This AMENDMENT UNDER 37 CFR 1.111 is filed in reply to the outstanding Office Action of October 4, 2002, and is believed to prima facie place this case in condition for allowance for the following reasons.

“VERSION WITH MARKINGS SHOWING CHANGES MADE”

FIG. 1A (PRIOR ART)

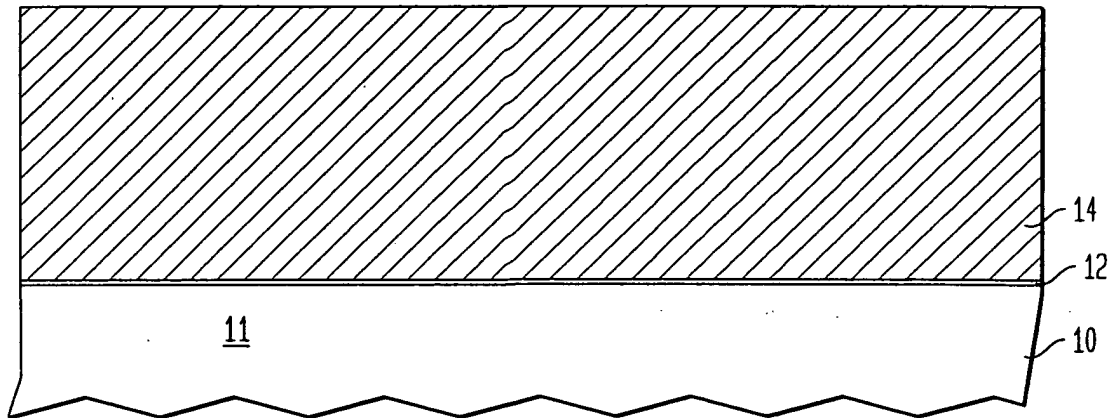
OK Responsive to paragraph 3 of the Official Action, proposed corrections to Figures 1A, 1B, 1C, 1D, 1E and 1F are attached hereto.

approved
Lake
